## PARA-PHERNALIA INC. PRODUCT SERVICE BULLETIN #2

**SUBJECT:** .260" ID Ripcord Housings

**STATUS:** Mandatory

**IDENTIFICATION:** All SOFTIE BACKPACKS with .260" ID housings Mini, Micro, Wedge, Survival, & Long Serial Numbers between 4500 & 5900

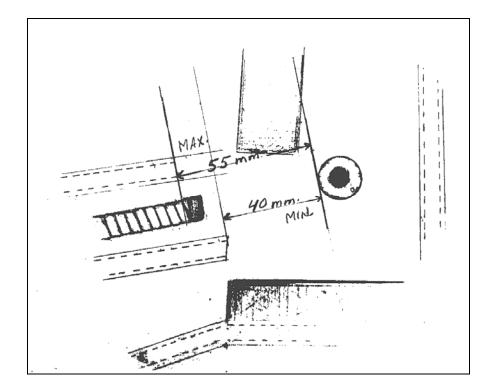
**BACKGROUND:** In January 1997 a smaller diameter (.260") ID ripcord housing was introduced on most SOFTIE backpacks. It has been brought to our attention that a few rigs with the smaller diameter housings have had a pull force in excess of 22 lbs. Further investigation has shown that the end of the housing was tacked too close to the grommet, causing the cable between the pins to wedge at the housing before the first pin had cleared the closing loop. In March 2000 a newer & larger (.344" ID) ripcord housing was introduced eliminating the possibility of this interference.

SERVICE: 1. Measure the distance from the edge of the grommet to the end of the metal ripcord housing (see diagram on page 2). The correct measurement should be from 40mm to 55mm. (1 9/16" to 2 3/16").
If the measurement is less than 40 mm., cut & remove the tacking at the harness end.

Retract the housing to the correct distance by rotating it counter-clockwise.
 Hand tack the housing at the harness end using Super Tack (Para-Gear Part Number T1050) in the standard method.

5. Verify that the ripcord housing is properly & securely tacked at the container end.
